26 August 2011

Edition 17

AUSTRALIAN NOTICES TO MARINERS

Notices 840 – 884

Note for chart AX 0754E.

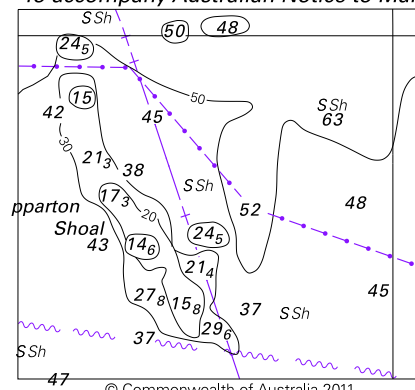
858* AUSTRALIA - WESTERN AUSTRALIA - Pepper Point to Cape Naturaliste - Chart note; legends
 Australian Hydrographic Service (AA467638)

AX 0754E [745/2011]

Amend	legend to <i>Fisheries (see Note)</i>	31° 18'.0 S	115° 00'.0 E
	legend to <i>Fisheries (see Note)</i>	32° 07'.5 S	115° 19'.5 E
Substitute	accompanying note for RLF note	31° 14'.0 S	115° 47'.0 E

© Commonwealth of Australia 2011
 Block for chart Aus 309 (53.1 x 48.9mm)

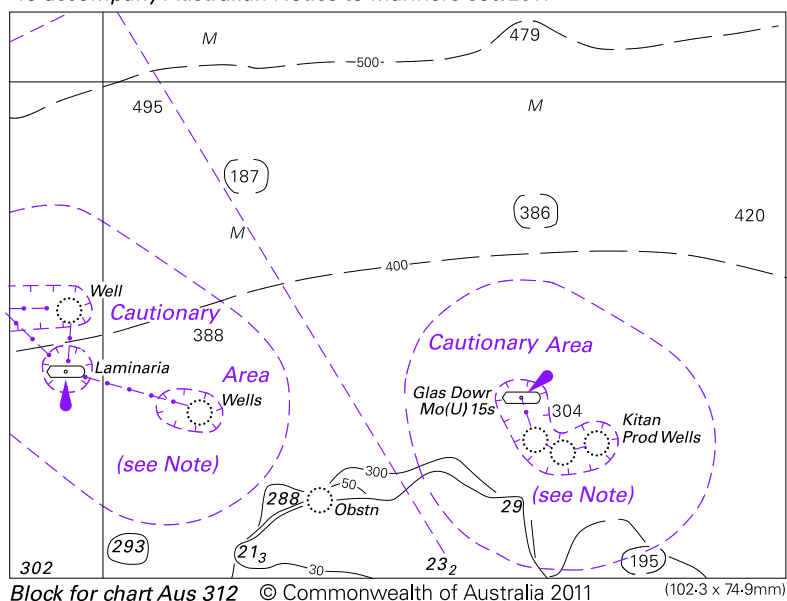
849* AUSTRALIA - NORTHERN TERRITORY - Shepparton Shoal - DepthsHMAS *Melville* (DHDB 1786843)**Aus 309 [797/2011]**

Insert	accompanying block	12° 04'.0 S	129° 55'.0 E
--------	--------------------	-------------	--------------

Block for chart Aus 312 © Commonwealth of Australia 2011

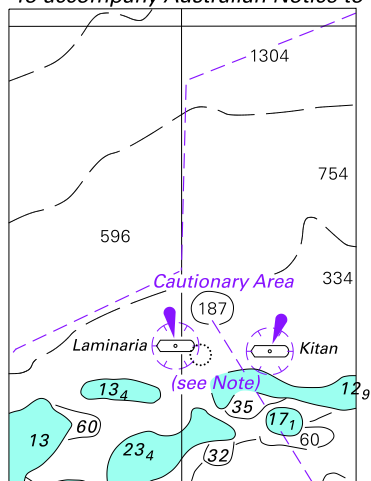
850* AUSTRALIA - TIMOR SEA - Sahul Banks - Oil field

Aus 312 [1166/2010]

Insert accompanying block
